TECHNICAL SERVICE BULLETINS

SERVICE BULLETIN

APPLICABILITY: STi Vehicles, All Model Years
SUBJECT: Towing Recommendations

NUMBER: 01-162-05
DATE: 06/28/05

APPLICABILITY: 2001MY and later Impreza WRX
SUBJECT: Modification to Rear Brake Caliper

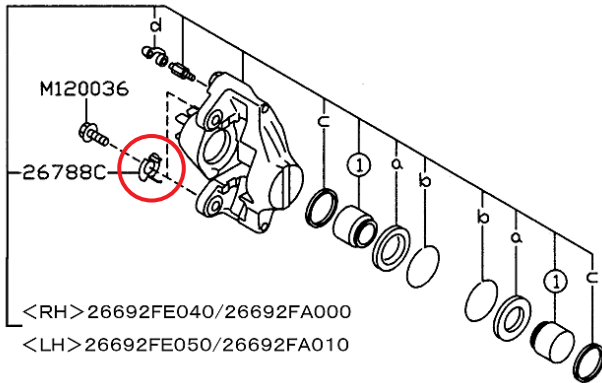
A production change was made to the rear brake caliper on 01MY and newer Impreza WRX. The washer between the caliper body and the backing plate has been discontinued. A change has been made to the caliper body to maintain the correct geometry, although the part numbers have not changed.

Note: Though there were design changes made to this part, the part numbers remain the same.

PART DESCRIPTION	OLD PART NUMBER	NEW PART NUMBER
Auto Clock Assembly	85201FE000	85201FE001

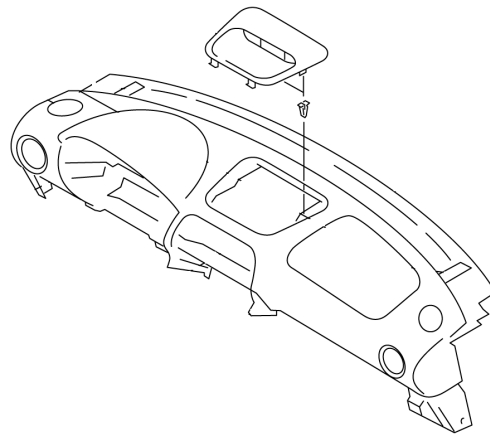
To correct this misjudgment condition, the circuit logic in the clock has been modified so that power will be supplied to the passenger airbag status indicator during cranking.

Check the part number of the clock currently installed in the vehicle. If equipped with the old style, replace it with the new style.
